# CITY OF ALBUQUERQUE

**Re: Albuquerque ER & Hospital  
4315 Wyoming Blvd. NE  
Traffic Circulation Layout  
Engineer's Stamp 10-12-21 (G19-D004D)**

TRAFFIC CIRCULATION  
LAYOUT

SP-1

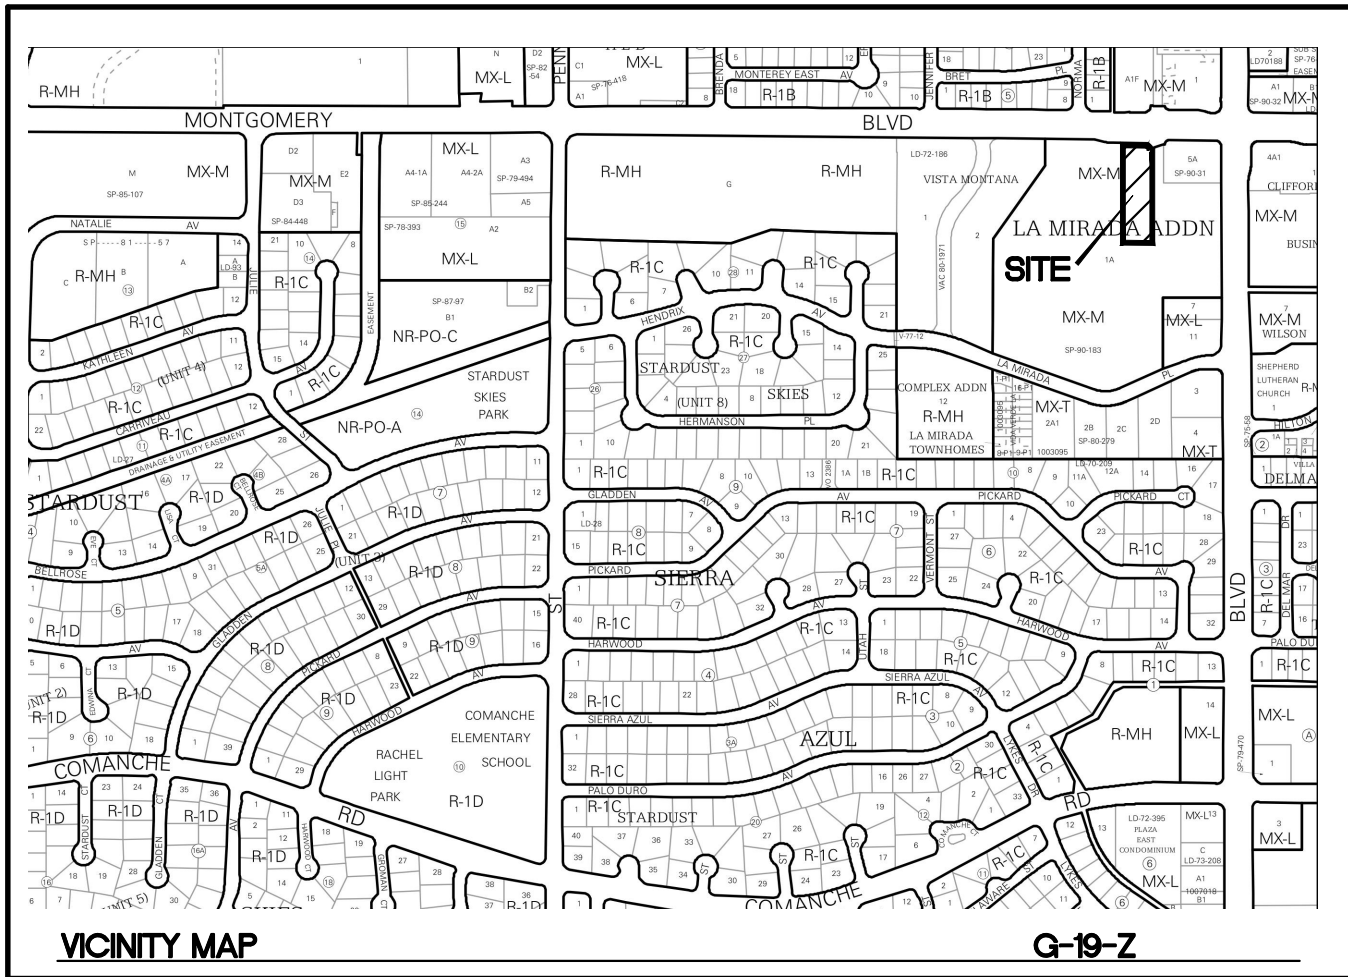
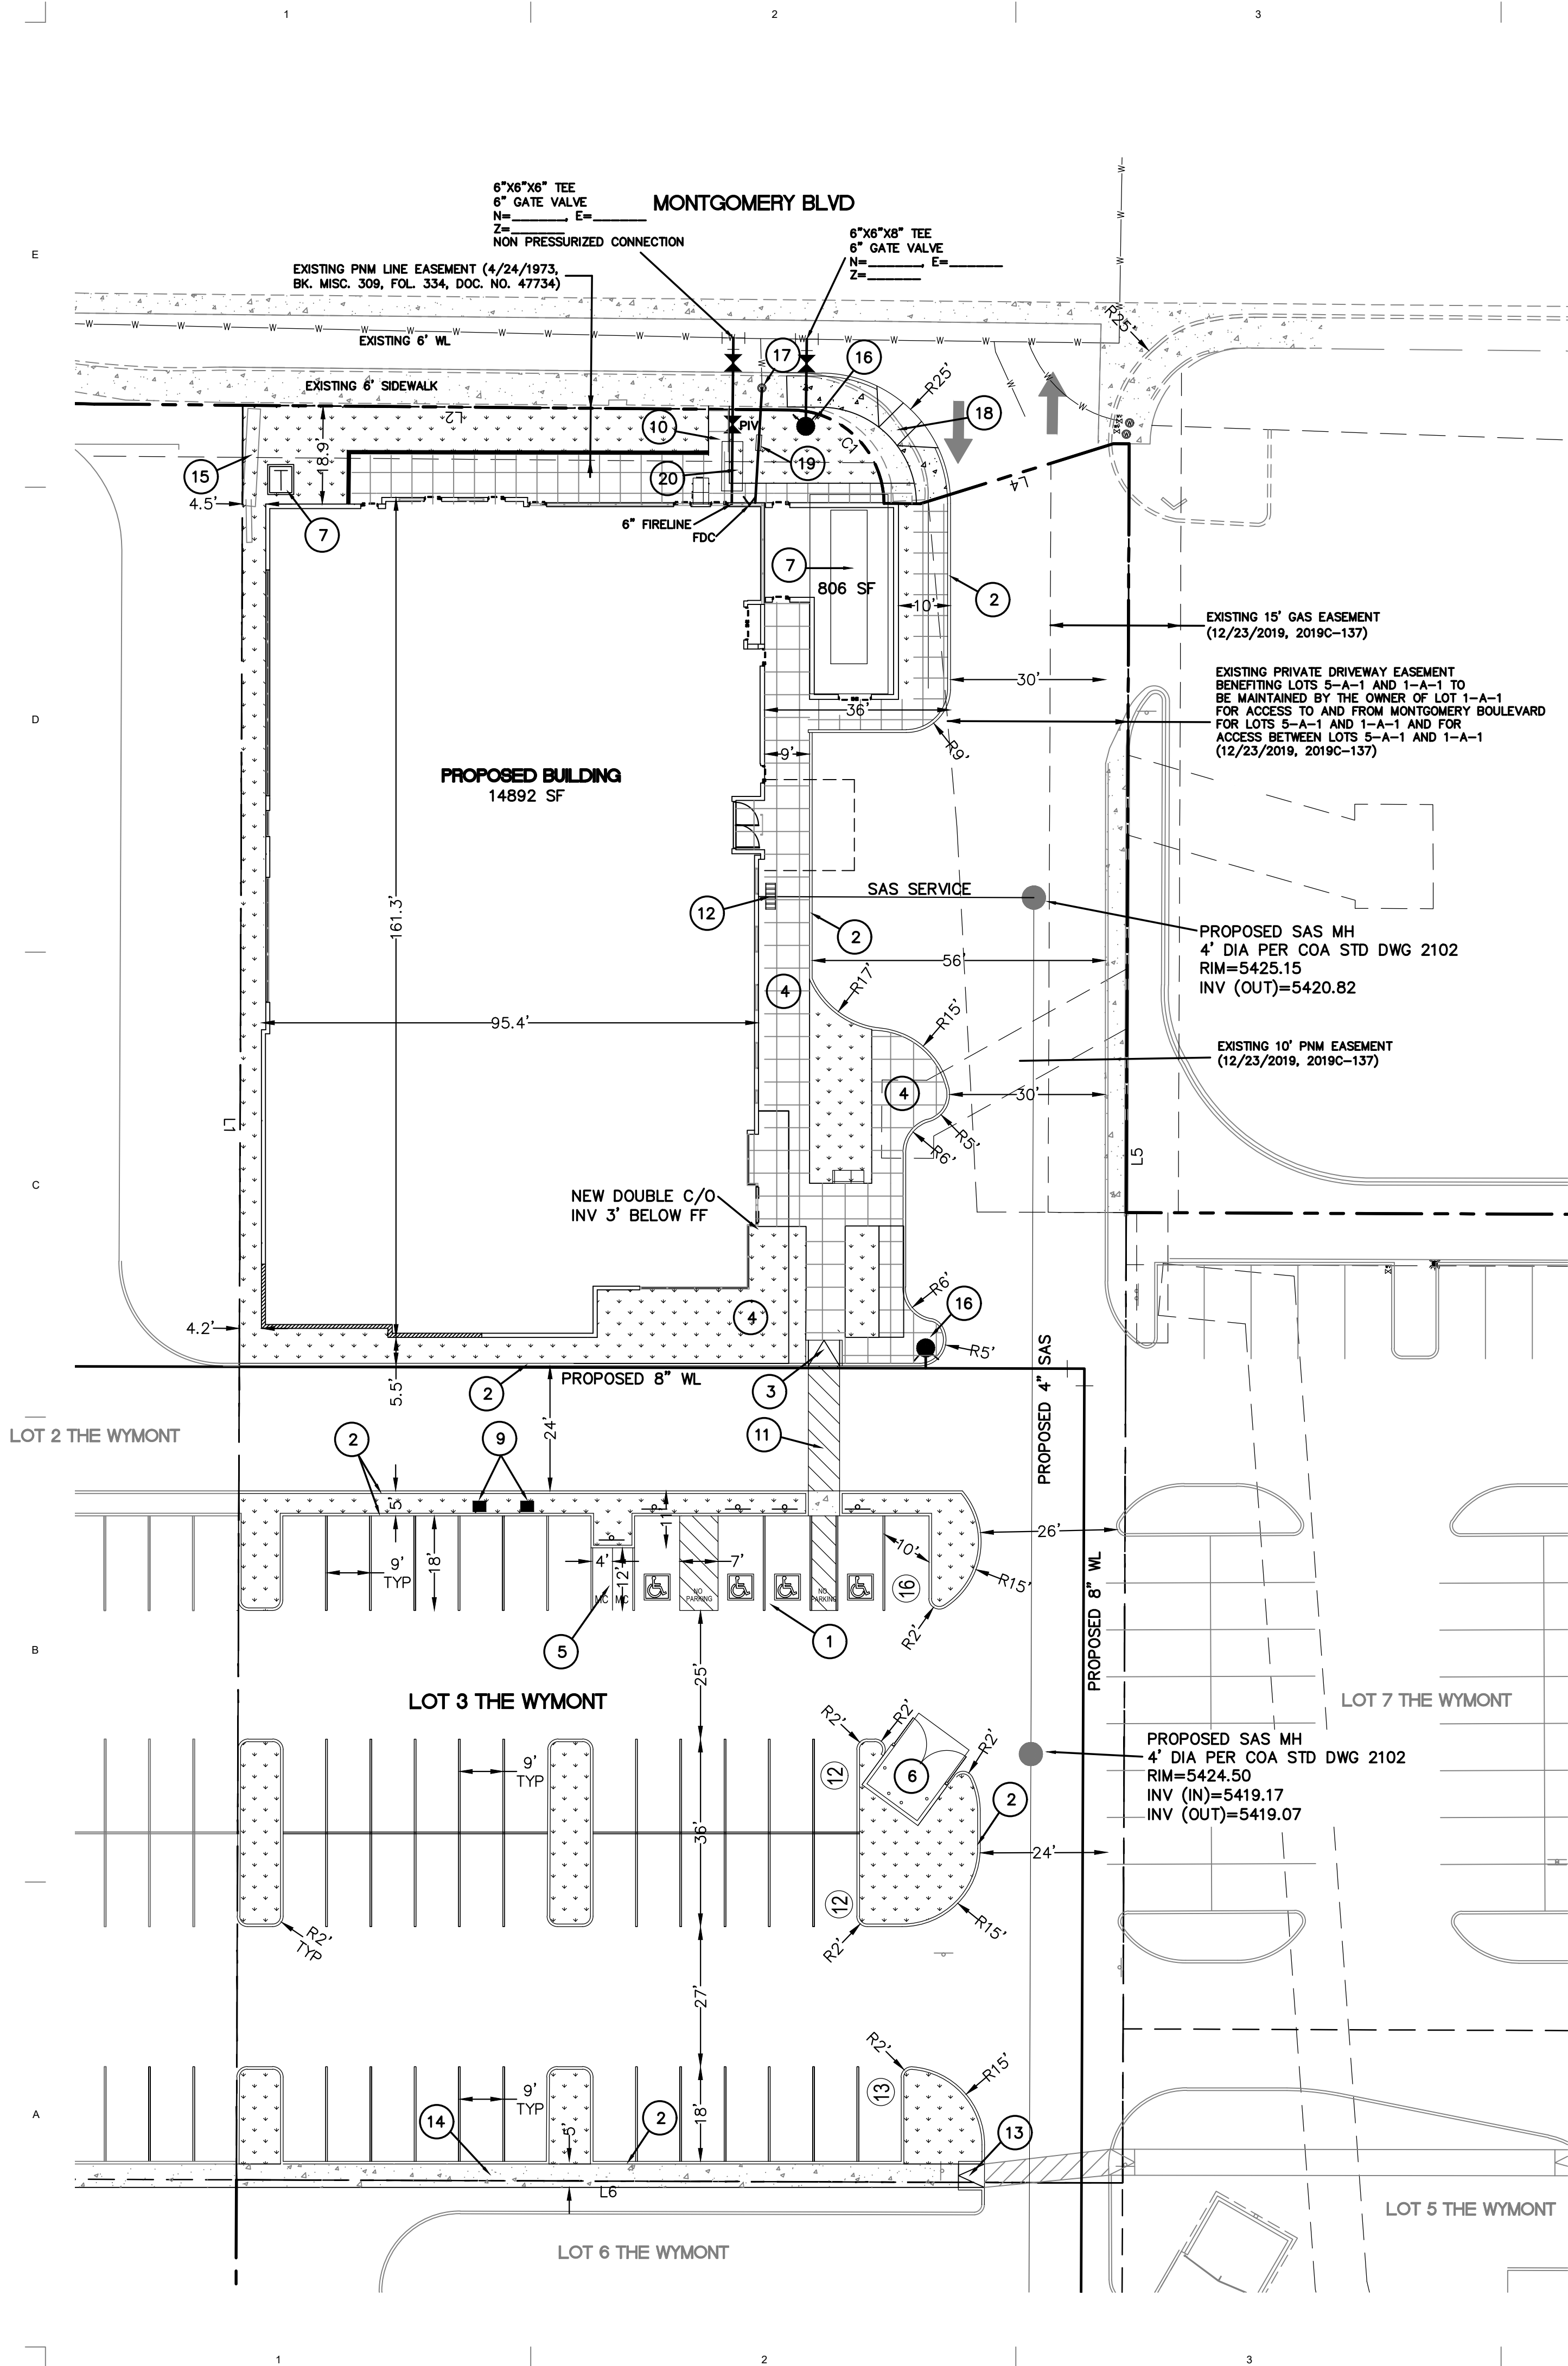
1. List the number of parking spaces required by the IDO as well as the proposed number of parking spaces including bicycle and motorcycle parking. Please coordinate with Zoning because you proposed less parking spaces than the required.
2. Keyed Note 1, 3, 12, 13, & 18: Details' sheet is missing. Provide details for each infrastructure, reference COA standard DWG.
3. Key note 2: Please clarify is it 6ft, or 6in?
4. Key note 7: All the proposed infrastructures should be located inside the property line.
5. Key note 9: Proposed charging station might conflict with overhang cars. Suggestion, you may provide curb bumpers in this conflict area.
6. Key note 11: provide cross walk striping details.
7. Identify the right of way width, medians, curb cuts, and street widths on Montgomery Blvd..
8. The minimum parking stall dimensions are:

9. The ADA accessible spaces must include an access aisle. Van accessible aisles should be 8ft wide; all others should be 5ft wide.
10. The ADA accessible parking sign must have the required language per 66-7-352.4C NMSA 1978 **"Violators Are Subject to a Fine and/or Towing."** Please call out detail and location of signs.

11. Motorcycle parking spaces shall be designated by its own conspicuously posted upright sign, either free-standing or wall mounted per the zoning code.

12. All bicycle racks shall be designed according to the following guidelines:
  - a. The rack shall be a minimum 30 inches tall and 18 inches wide.
  - b. The bicycle frame shall be supported horizontally at two or more places. Comb/toaster racks are not allowed.

13. Bicycle racks shall be sturdy and anchored to a concrete pad.
14. A 1-foot clear zone around the bicycle parking stall shall be provided.
15. Bicycle parking spaces shall be at least 6 feet long and 2 feet wide.

16. Per the IDO, a 6 ft. wide ADA accessible pedestrian pathway is required from the public sidewalk to the building entrances. Please clearly show this pathway and provide details.

17. Per DPM, a 6 ft. wide ADA accessible pedestrian pathway is required from the ADA parking stall access aisles to the building entrances. Please clearly show this pathway and provide details.

18. Parking areas shall have barriers to prevent vehicles from extending over public sidewalk, public right-of-way, or abutting lots.
19. Refuse vehicle maneuvering shall be contained on-site. The refuse vehicle shall not back into the public right of way; provide a copy of refuse approval.

20. Provide Fire Marshal Approval.
21. It is not apparent what type of pavement surface is being proposed. A hard driving surface will be required as part of this proposed project for parking area and drive aisles.

22. Please provide a sight distance exhibit
23. Show the clear sight triangle and add the following note to the plan: "Landscaping and signage will not interfere with clear sight requirements. Therefore, signs, walls, trees, and shrubbery between 3 and 8 feet tall (as measured from the gutter pan) will not be acceptable in the clear sight triangle.

24. Add note for existing Pedestal Sign to be located inside private property which includes Air Space.
25. Please specify the City Standard Drawing Number when applicable.

26. Shared Site access: driveways that straddle property lines, or are entirely on one property but are to be used by another property, shall have an access easement.

Please include a copy of your shared access agreement with the adjacent property owner and an APPROVED PLAT for subdividing lot.

27. Water Tap: Will this be done by mini work order thru Water Authority? Explain since it is impacting COA/Public ROW.
28. Please add a note on the plan stating "All improvements located in the Right of Way must be included on the work order."
29. Add a note stating "All broken or cracked sidewalk must be replaced with sidewalk and curb & gutter." A build note must be provided referring to the appropriate City Standard drawing.
